CITY COUNCIL AGENDA ITEM COVER MEMO

Agreement with Angelo Iafrate Construction Company, Inc.

Resolution authorizing the Mayor to enter into an agreement with the low bidder, Angelo Iafrate Construction Company, Inc., for Veterans Drive Extension, Option #1, Project No. 65-11-RD02

**CONTRACT BETWEEN CITY OF HUNTSVILLE
AND
ANGELO IAFRATE CONSTRUCTION COMPANY, INC.
FOR
VETERANS DRIVE EXTENSION, OPTION #1
PROJECT NO. 65-11-RD02**

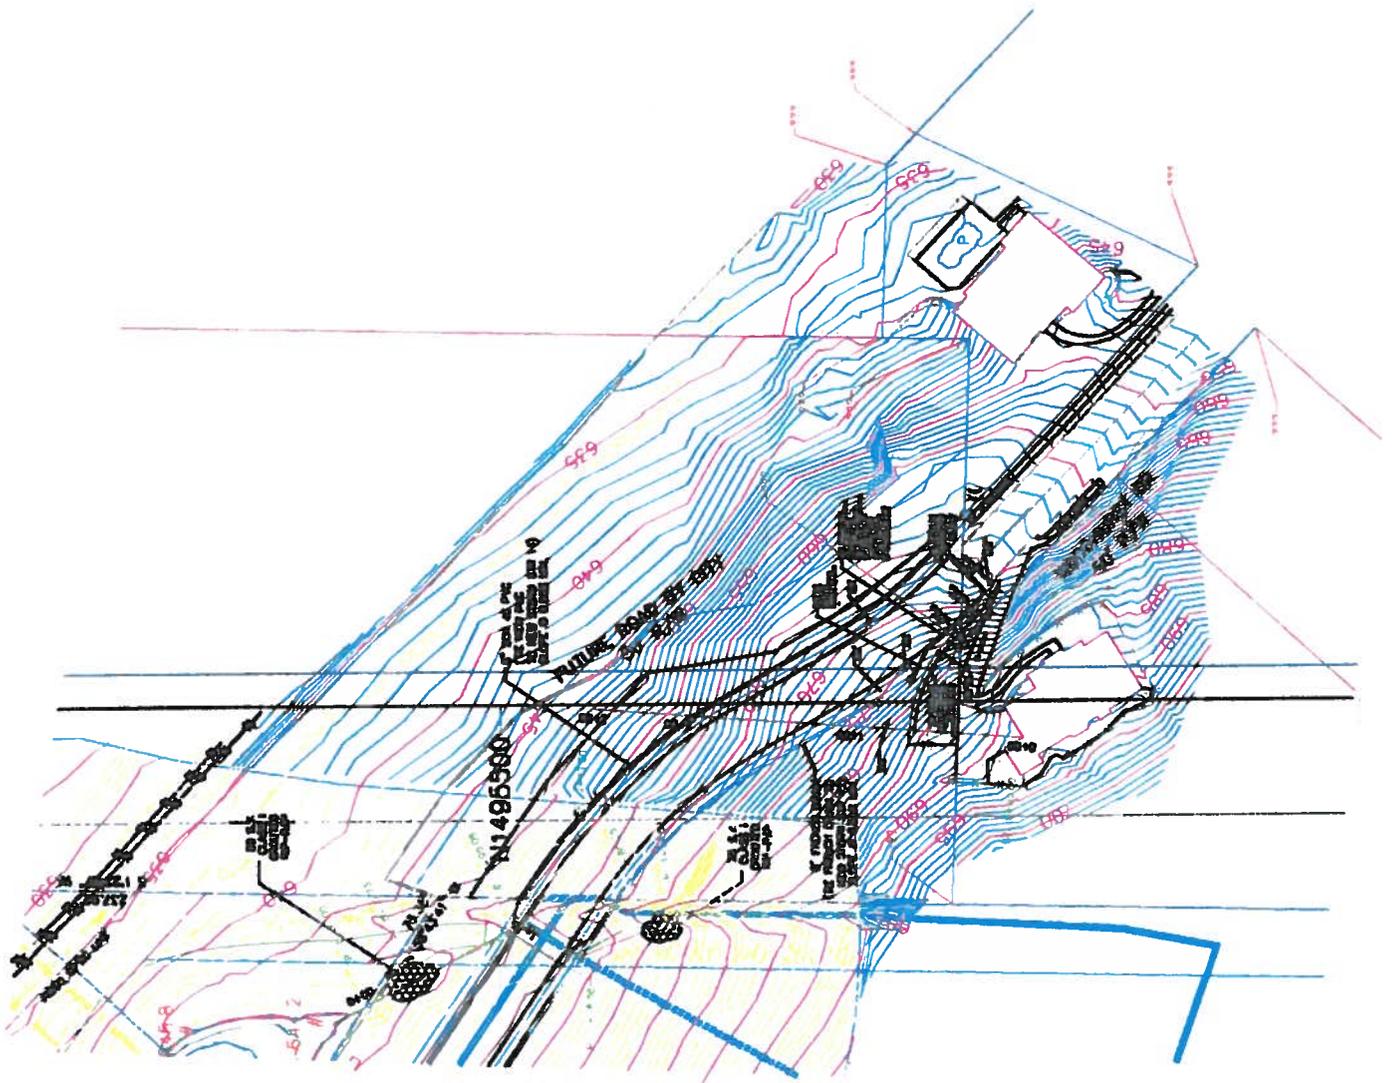
**Q: With it being a lump sum in price, Contractors need to know exactly what work will be done.**

**A:** The only work that will be done is from Station 11+22.63 to the end of the construction. If you look on Sheet 5 of the plans, in the upper right hand corner where it says "Future Road by City" that is the project. Everything before that has been built. Contractors may want to drive out to the site and look at the condition of the road so they can see what is there.
